TECHNICAL STAFF REPORT

CASE: Preliminary Subdivision Plan
14251 & 14275 Park Center Drive
Laurel, Maryland 20707

REQUESTED ACTION: Subdivision Plan approval to construct townhouse dwellings.

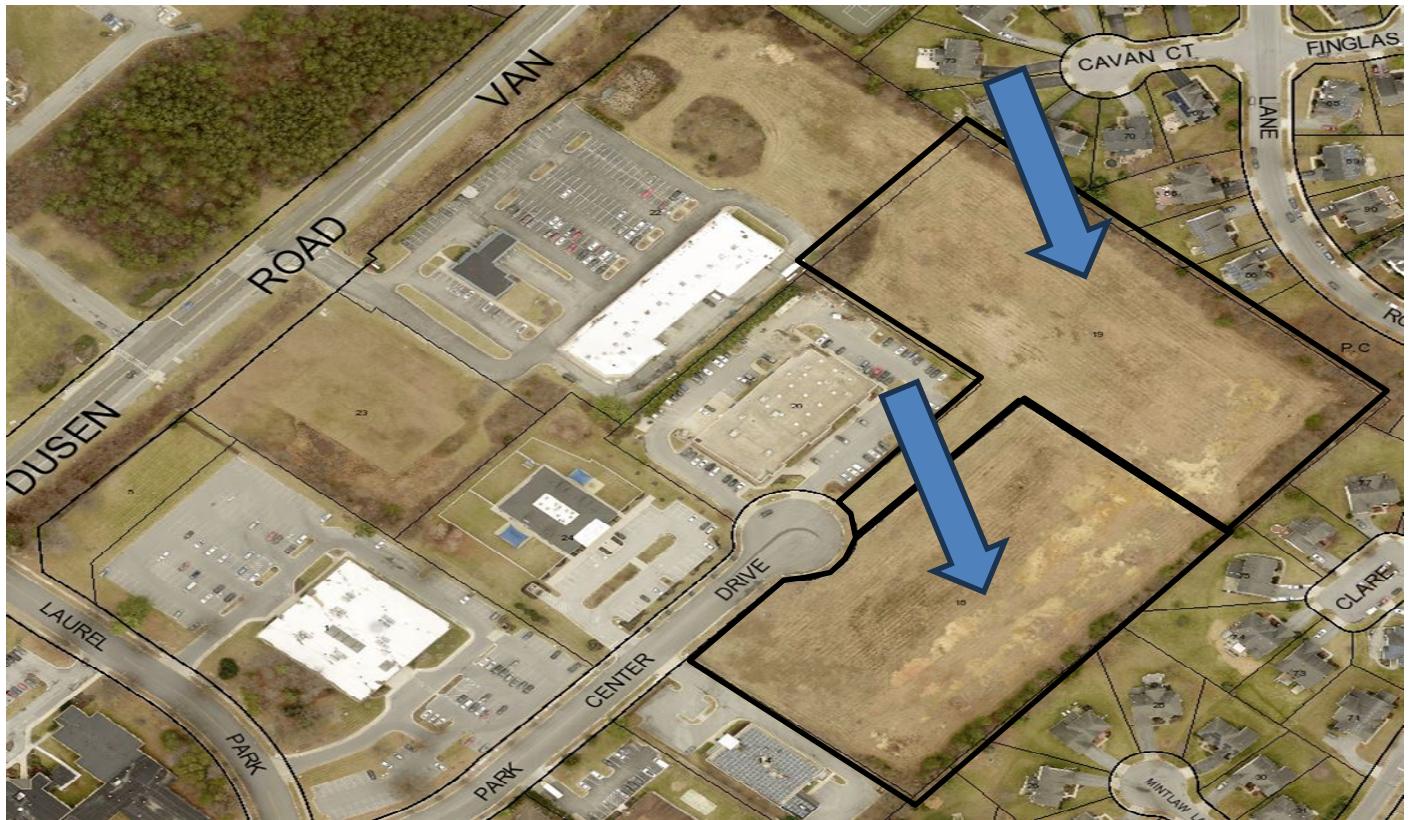
Below is an overhead view of the property. The blue arrows show the two lots for the proposed dwellings.
